Aercoustics Project #: 16424.00

Subject: Reid Road Quarry
Noise Impact Study Report Addendum #1**1 Introduction**

This letter serves as addendum #1 to the noise impact study (Noise Study)¹ to address some changes to our noise impact study. Note that the noise monitoring and receptor sound level limit revisions were previously provided in a memorandum issued by Aercoustics on December 4, 2019.

Figure 1: Concept of incorporating existing berm as noise control feature
(also illustrates the position of a potential culvert at the base of the acoustical barrier)

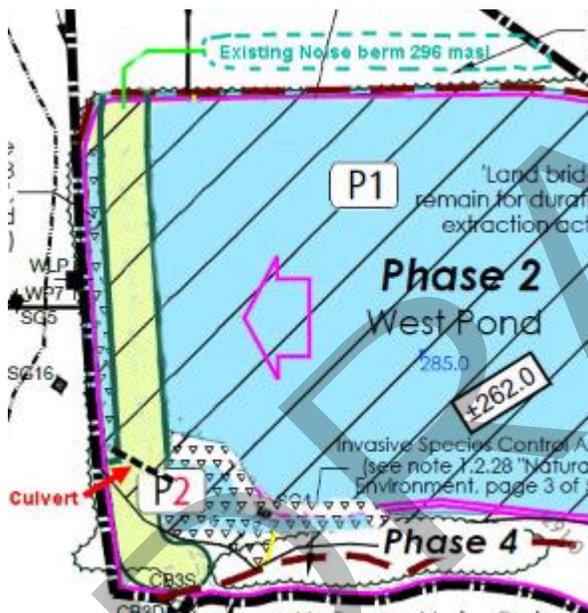
A culvert installed at the base of the barrier should not compromise the noise control mitigation of the acoustic barrier, if it is positioned such that there is no line of sight between quarry equipment and noise receptors through the culvert

This existing berm has a top elevation of EL296m along most of its length and tapers down on the Phase 2 lands west end. As this elevation is the same as that recommended as the acoustical barrier in the Noise Study, this existing topography can be used as part of the acoustical barrier noise control. The addition of a noise barrier, likely in the form of an acoustical fence, will be required to increase the existing berm top elevation particularly on its west end to satisfy the EL296m top of barrier elevation requirement.

The Figure below illustrates the concept.

Figure Title
 Plan highlighting
 noise controls changes

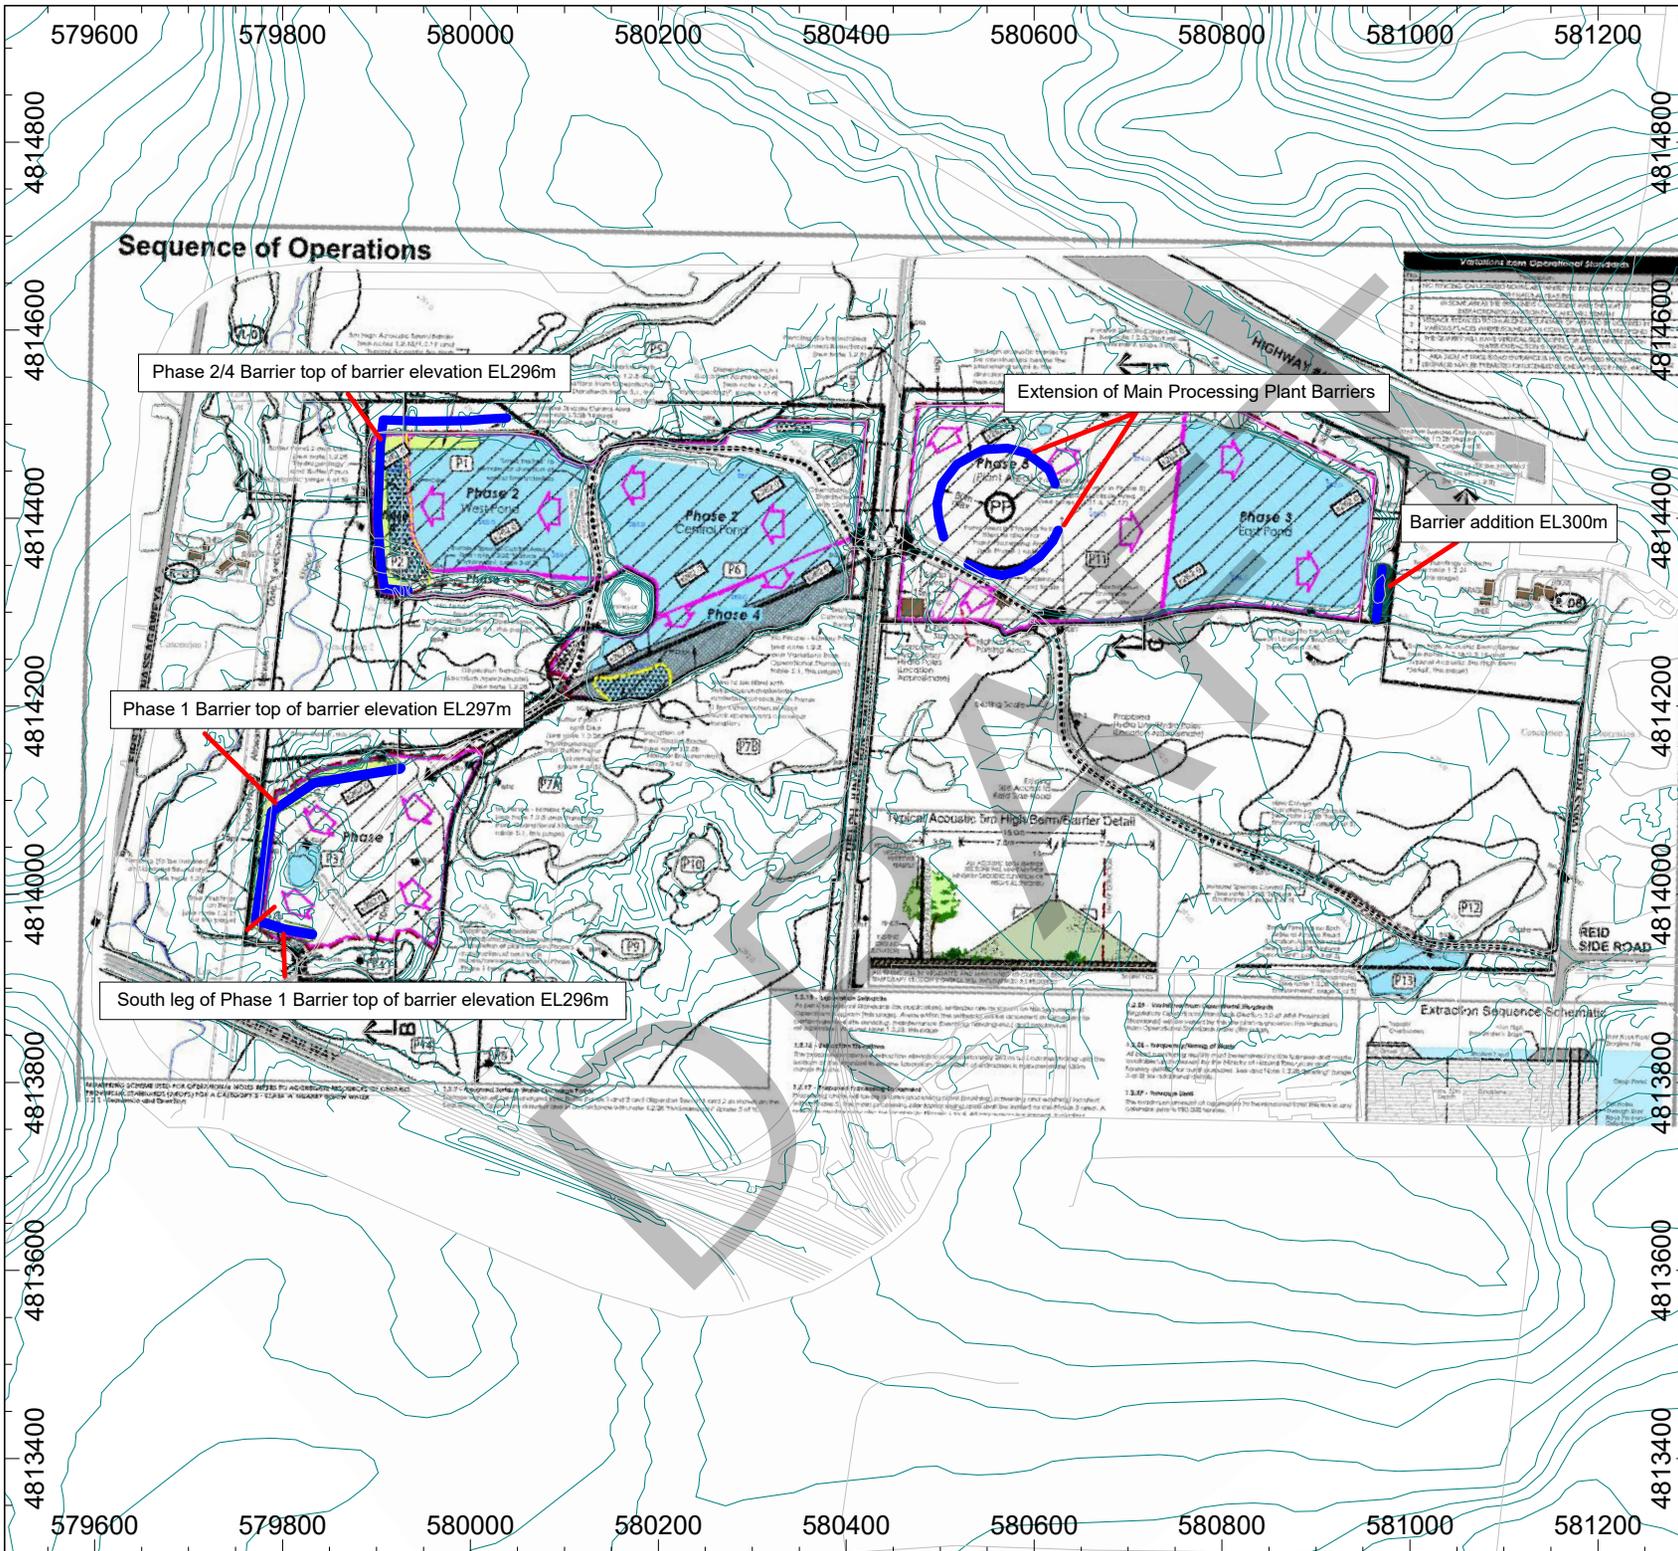
To address the change in receptor sound level limits, the following revisions to the noise controls are recommended:

1. Increase the Phase 1 perimeter berm height
2. Add extensions to the main processing plant barriers
3. Minor realignment of the Phase 2 barrier to incorporate existing berm
4. Add an extension to the primary crusher barrier in the Phase 4, central pond parcel.
5. Add an acoustic barrier on the southeast side of Phase 3

The recommended changes in the noise controls are illustrated in Figure 5. The following sections present the complete list of noise control recommendations with the inclusion of the above listed recommended changes. In addition, minor revisions were made to improve clarity as well as the recommendations of the perimeter barriers have been updated; specifying top of barrier elevations rather than barrier heights.

4. Prior to aggregate operation of the main processing plant, acoustic barriers shall be constructed as follows:
 - a. An acoustic barrier shall be constructed to provide shielding of the main processing plant to the south and north with extent and position as illustrated in Figure 5. The acoustic barrier shall be 5m in height and be positioned a maximum distance of 50m from the main processing plant.
 - b. An acoustic barrier shall be constructed on the southeast side of the Phase 3 lands with extent and position as illustrated in Figure 5. The acoustic barrier shall have a top of barrier elevation of EL300m.

5. An acoustic barrier shall be constructed on the west and northwest end of the Phase 1 lands, with position and extent as illustrated in Figure 5. The acoustic barrier shall have a top of barrier elevation of EL297m, with the exception of its south leg. This south leg shall have a top of barrier elevation of EL296m. The acoustic barrier can be removed when extraction in the Phase 1 lands are complete.
6. An acoustic barrier is required to shield the primary crusher from receptors to the project northwest and southwest, towards receptors R01 & R11, as well as towards VL-07 & VL-08 if dwellings are present. The acoustic barrier shall be 5m in height and be positioned a maximum distance of 5m from the primary crusher.

7. Prior to extraction in Phase 2, an acoustic barrier shall be constructed on the west end of the Phase 4 lands and the northwest side of the Phase 2 lands, with position and extent as illustrated in Figure 5. The acoustic barrier shall have a top of barrier elevation of EL296m. This barrier will be a combination of existing topography, existing earth berm to the north, and a new barrier construction at the corner and at the west end of the pond. The acoustic barrier can be removed when extraction in the Phase 2 and Phase 4 lands are complete.
8. An acoustic barrier is required to shield the primary crusher from receptors to the project west, towards receptors R01-R03. The acoustic barrier shall be 5m in height and be positioned a maximum distance of 5m from the primary crusher.
